## **FORDPERFORMANCE**

## Technical Service Bulletin - 01

Mustang Dark Horse R Rear Dampers

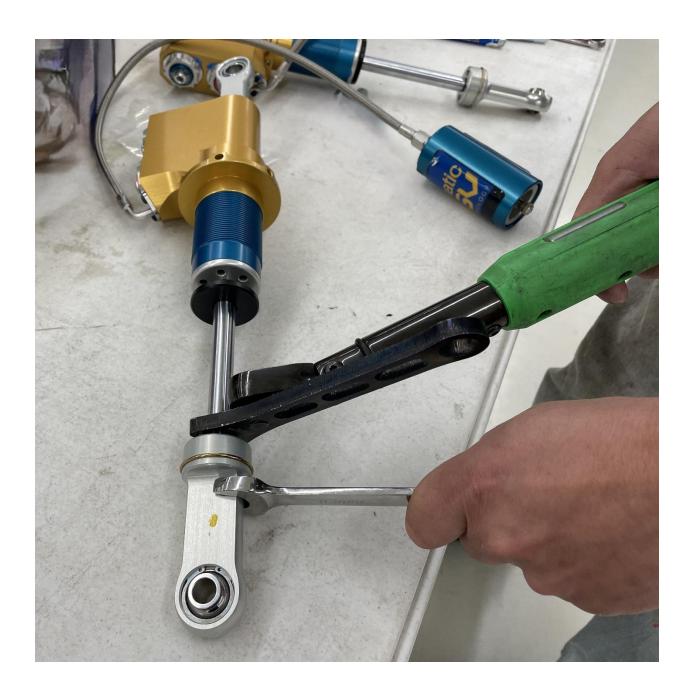
Issue: Rear Dampers – the shaft end eye and nut are not properly tightened as delivered.

Action: Follow the procedure to tighten the shaft end eye.

- Fully seat nut on shock shaft
- Apply 2-3 drops of Loctite 243 to shaft end eye threads
- Hold eye with an appropriate tool, and tighten nut to 20 ft-lbs

Special holding tools for the nut, similar to tool shown below, will be supplied for vehicle owners at the Mid-Ohio race event.
